# SERVICE BULLETIN

ENGINE – FAN CASE ASSEMBLY – PROVIDE SHORTER FAN EXIT GUIDE VANE BOLT TO ELIMINATE INTERFERENCE BETWEEN BOLT AND EEC MOUNT BRACKET – CATEGORY CODE 4 – MOD.ENG-72-0140

V2500-ENG-72-0140

Alteration of the FEGV Bolts  
Fig.2

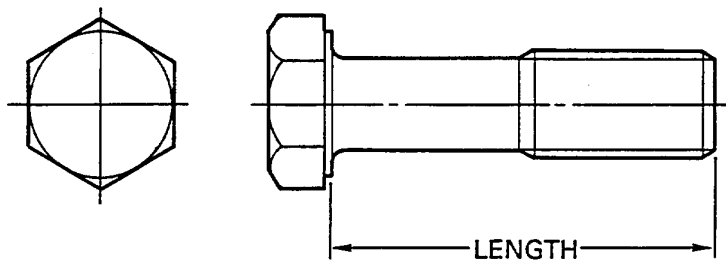
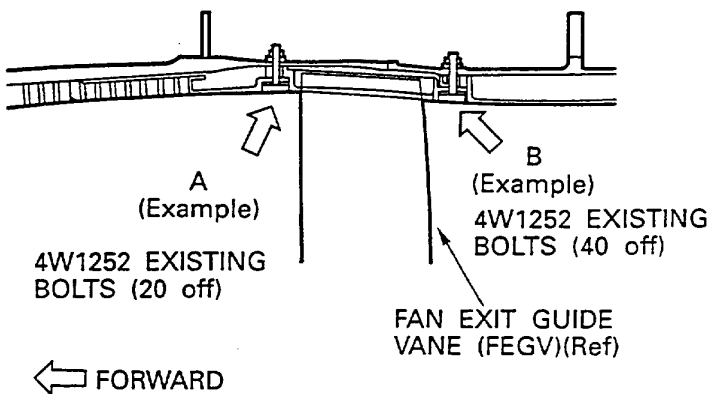
\*REMOVE 4W1252 (60 off) BOLTS FROM A AND B ALL POSITIONS AND INSTALL NEW 4W1250 (60 off) BOLTS TO THE A AND B ALL POSITIONS

*EXISTING BOLT LENGTH	1.125(28,6)
NEW BOLT LENGTH	1.000(25,4)

NOTE: Existing 4W1252 bolt length is 1.125in (28,6mm) and new introduced bolt length is 1.000in (25,4mm).

- (1) Find the outer platforms of the FEGV that is installed on the engine.
- (2) Remove the 20 4W1252, Bolts which attach the FEGV to the Fan Case Assembly refer to Reference (3), Chapter/Section 72-32-88, Removal (Refer to Figure 2).
- (3) Install the new 20 4W1250, Bolts refer to Reference (3), Chapter/Section 72-32-88, Installation (Refer to Figure 2).
- (4) Torque the Bolts to 85 to 105 lbfin (10,00 to 12,00 Nm).
- (5) Remove the 40 4W1252, Bolts which attach the FEGV to the Fan Case Assembly refer to Reference (3), Chapter/Section 72-32-88, Removal (Refer to Figure 2).
- (6) Install the new 40 4W1250, Bolts refer to Reference (3), Chapter/Section 72-32-88, Installation (Refer to Figure 2).
